14 December 2018

#### Primary Gold Limited – Environment Impact Statement (EIS), 14A Amendment to the Toms Gully Underground Project Site - Modifications Reflective of Placing New Waste Rock and, Existing and New Tailings in the Pit

Figure 2: Modified Toms Gully Underground Project site layout (to be submitted as part of the EIS Addendum to the Supplement).

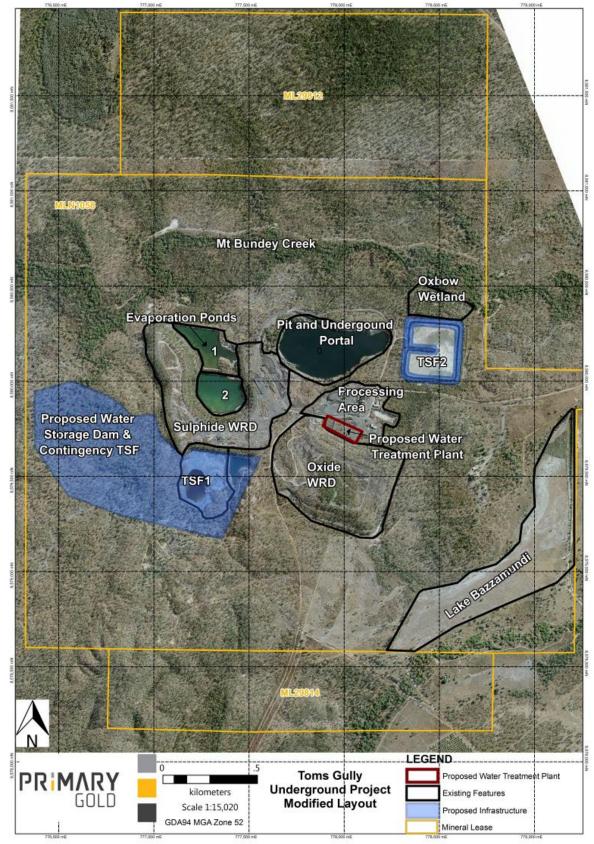
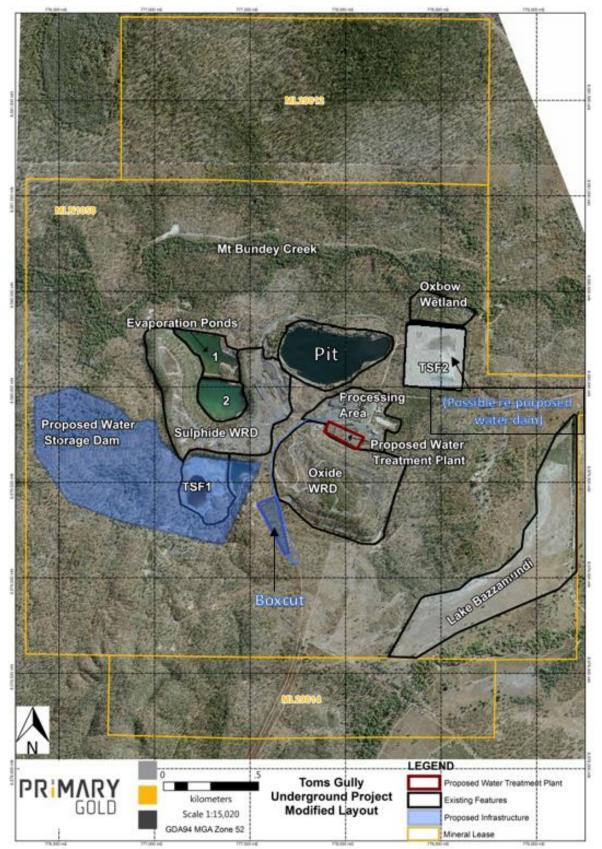
Details of the existing proposal can be located in the previous Draft EIS (dated 21 September 2018), Section 14A (dated 8 June 2018) and EIS Supplement (dated July 2018). This section will be limited to a discussion and comparison of the intended alterations. The proposed changes to the footprint of Toms Gully Underground Project are outlined in Figure 1 (EIS Supplement layout) and Figure 2 (revised layout).

The proposed alterations can be summarised as follows:

Construction of a Boxcut (two hectare in area) and associated decline to access the Toms Gully ore body further down trend/dip. A Boxcut removes the requirement to enter the ore body via the existing Toms Gully open cut pit and underground workings.

- 2. Leave a 100 metre rock barrier pillar (i.e. Exclusion Zone) between the old underground workings and the proposed underground working.
- 3. Placement of all existing and future tailings into the Toms Gully pit under the existing pit water level (i.e. under a water blanket) using a floating head system. The system is proposed to discharge the tailings deeper in the water profile to avoid oxygenated water. Tailings will be placed in the pit whether processed or not.

- 4. Moving underground waste rock to surface during operations via the proposed decline and then positioning of that waste rock into the pit beneath the water. This process will occur within 48 hrs.

- 5. Full dewatering of the pit is no longer required reducing dewatering from 4.7 gigalitres to 1.7 gigalitres. The water treatment option remains the same with surface water, water within water holding facilities, dewatering and water displaced from the pit potentially being treated.

- 6. All current tailings within Tailings Storage Facility (TSF) 1 and 2 are placed in the pit removing the requirement to upgrade both facilities to ANCOLD 2012 guidelines and lining dependent on the nature of the tailings.

- If demonstrated that TSF2 can meet ANCOLD 2012 guidelines and seepage can be managed. TSF2 repurposed to a water storage dam during operations. Ultimately TSF2 removed and area rehabilitated at closure

- 8. Remove the need for the proposed contingency TSF that covers a 9 hectare area as all tailings will be placed in the pit.
- 9. Treat pit water insitu by the addition of lime or caustic or Virtual Curtain to lower the pH and remove metals from the water column.

Figure 3: Proposed Boxcut Positioned Down Dip of the Ore Body.

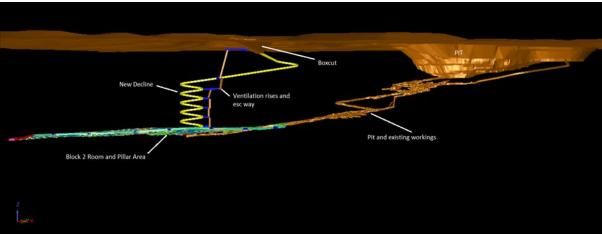
To access the ore, a Boxcut is to be located south east of TSF1 in an area of disturbed ground Figure 2. The portal and decline are located west of the near vertical fault called the "Crabb fault". Also the bottom of the Boxcut will be founded in fresh rock allowing the portal to be within stable ground conditions. Positioning of the decline negates having to transverse the fault, making development of the decline safer and easier. A 100 metre rock barrier pillar (i.e. Exclusion Zone) will be left (Figure 4). This rock barrier provides both horizontal and vertical separation between the two workings to allow the retention of pit water and positioning of the tailings and waste rock into the pit during operations.

Figure 4: Proposed Underground Workings Relative to the Barrier Pillar.

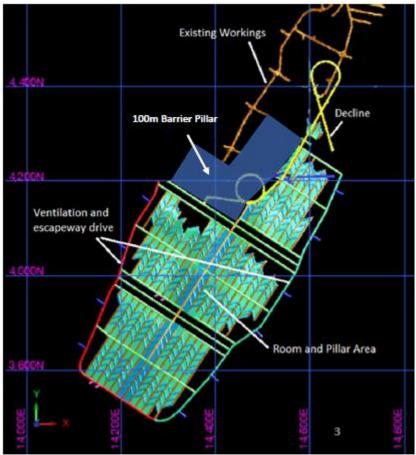
At this point excavated material from the Boxcut is considered to be waste that needs to be placed into the pit unless testing determines the material is non-acid forming. If non-acid forming and suitable, the material will be used to cap the top surface of the existing waste rock dumps to limit the ingress of water through the waste rock pile. The Boxcut material now increases the total waste to 1.51Mt, comprising 0.66Mt of Boxcut waste and 0.85Mt of underground waste.

Figure 5: Example of Telescoping Stacker

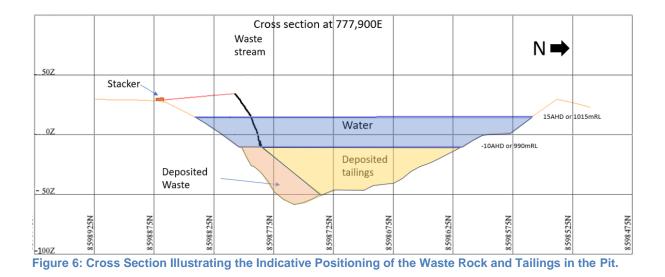
Primary propose to use a hopper and conveyer system ("Stacker") to drop waste rock approximately 60m from the pit edge towards the middle of the pit. The waste will fall through the water column and hit the wall where the pit slopes are steepest allowing the waste to slide to the bottom of the pit. The stacker is a mobile conveyer that is available with telescopic versions that can reach distances of 60m. Figure 5 and 6 below show the waste tipping method of a Stacker and final position of backfill material.

The Stacker is capable of moving 725tph or 240m3 per hour. During operations a daily average of 600 tonnes will require placement that can be easily achieved based on the known operational performance discussed earlier. The Stacker will be placed at the edge of the pit, so it can transport waste towards the internal sections of the pit.

The mode of operation is to truck the waste to the Stacker over a 24 hour period. Waste is loaded daily into the Stacker hopper and the waste is transported to end of the Stacker conveyor belt and dropped into the pit at a distance of 60m from the pit perimeter. Due to the forward velocity of the material as it leaves the conveyor belt there will be an additional distance beyond the length of the conveyor that waste rock is thrown (estimated at least 5m). Through this process waste rock will be in the pit within 48 hours.

Figure 7: Comparison of Original Dewatering Volumes and Altered Dewatering Volumes.

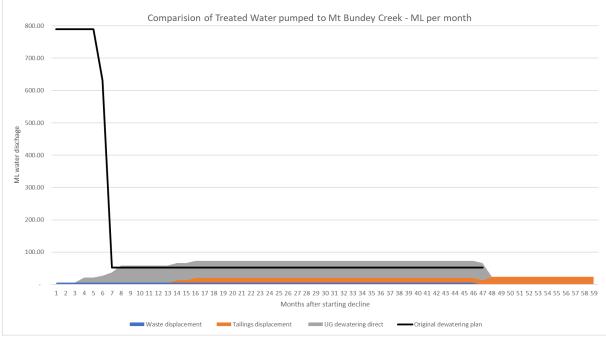
In the EIS Supplement it was intended to fully dewater the Toms Gully pit and remediate the underground workings to gain access to the Toms Gully orebody. To achieve this it was estimated that a total of 4.7 gigalitres of water would need to be removed and treated before discharge to Mt Bundey Creek, transfer to a third party and/or use across the site. To achieve the dewatering of the pit and water treatment it was expected to take 200 days that would occur during the wet season and dry season. The amount of water to be disposed by either usage or discharge would be 272 litres per second. If all the water was only discharged to Mount Bundey Creek (assuming the Mount Bundey channel is 12 metres wide) the rate of discharge would fill the creek to an estimated 0.24m depth and flow at 0.09m/s assuming a uniform creek bed and a 1 in 500 slope. From these calculations it is

anticipated that the amount of water is likely to result in Mount Bundey Creek flowing during the dry season.

Under the new proposal by placing tailings and waste rock in the pit beneath the water level only the displaced water would need to be removed and treated. Compared to original proposal, only 27.6 litres per second or 11 times less water would need to be disposed of by either usage or discharge. This maximum discharge is attained 16 months after underground development starts allowing for a stepped increase in treatment capacity compared to the rapid dewatering and discharge associated with the previous proposal. Figure 7 provides a comparison of the nominal discharge volumes. Note this figure provides a worst case scenario as it assumes all water goes to Mt Bundey Creek does not take into account water usage by the process plant or third parties. The greatly reduced discharge volumes result in a reduction the water depths and flow rates during the early part of operations in Mt Bundey Creek during both the wet and dry seasons

Figure 8: Nominal Water Volumes to be Treated during Operations.

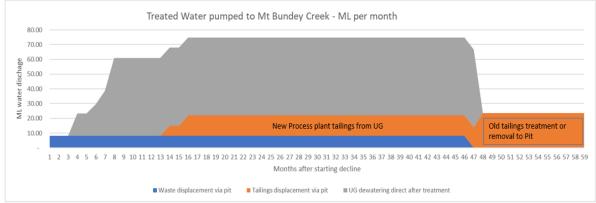
The proposal does not change the amount of dewatering required during operations. Figure 8 details the nominal volumes of the combined dewatering and water displacement that will require treatment and disposal. This figure provides a worst case scenario as it assumes all water goes to Mt Bundey Creek and does not take into account water usage by the process plant or third parties.
